Applicant(s): J. Bevirt  
Assignee:  
Title: Mounting Apparatus Using Ball and Socket Joints With Gripping  
Features  
Serial No.: 11/324,994 Filing Date: 01/03/2006  
Examiner: E. Garcia Group Art Unit: 3679  
Docket No.: 1040-US

**REQUEST FOR CONTINUING EXAMINATION**

FIGURE 6A

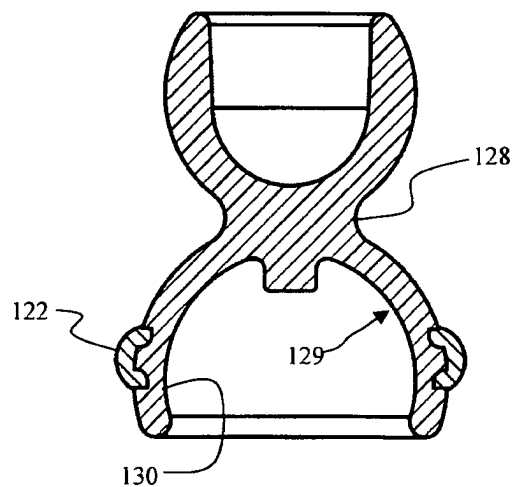
The Office Action has requested darker cross hatching for the grip rings in Figures 6A and 14A. This change has been made. The Office Action has requested that the hatching for the gripping portion in Figures 6A and 14A use dark lines. This change has been made. The Office Action has stated that the thin (hatch) lines in Figures 6A and 14A appear to be broken. Although not submitted as broken, perhaps the thinner aspect of the lines presented reproduction problems at the Patent Office. The thinner hatch lines in these figures have been redrawn to be thicker, and more clearly solid, yet still thinner than the alternating hatch lines.

The Office Action has objected to the drawings. Replacement drawings have been prepared and are attached to this paper. Figures 6A and 14A have been altered.

FIGURE 14A

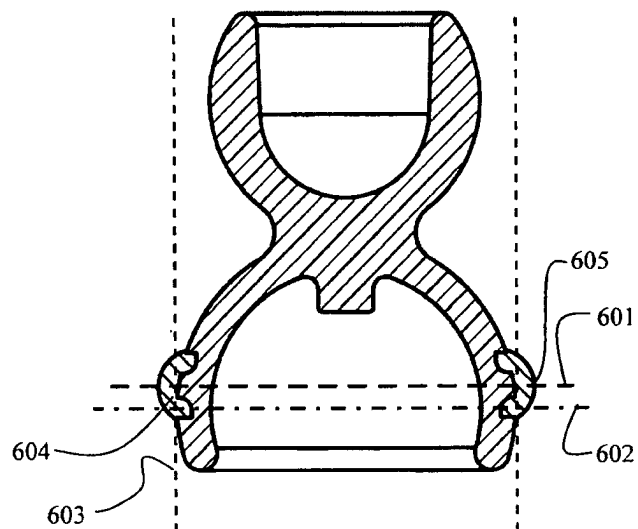
The Office Action has commented on the vertical tangent lines 603 of Figure 14A. The lines have been redrawn to more clearly show the tangent aspect. The Office Action has also commented on the centerline 601, stating that the line is offset from the center of the ring. Although it appears to Applicant that it is indeed a centerline as previously submitted, the

Figures 14 and 14a illustrate a geometric relationship of the grip ring and the connector body according to some embodiments of the present invention. Vertical lines 603 are vertical tangent lines at the outer periphery of the outside of the connector body. These intersect the horizontal 602 through the widest part of the external periphery of the connector's internal socket receiving cavity at a point 604. The centerline 601 of the grip ring ~~601~~ 122 is seen further from the base of the connector than the horizontal 602 through the widest portion of the connector. A midpoint 605 is seen on the grip ring along the centerline 601 of the grip ring.

drawing has been clarified in this area in response to the Office Action's concern. Also, a numeric reference designator has been added for the midpoint of the gripping portion.
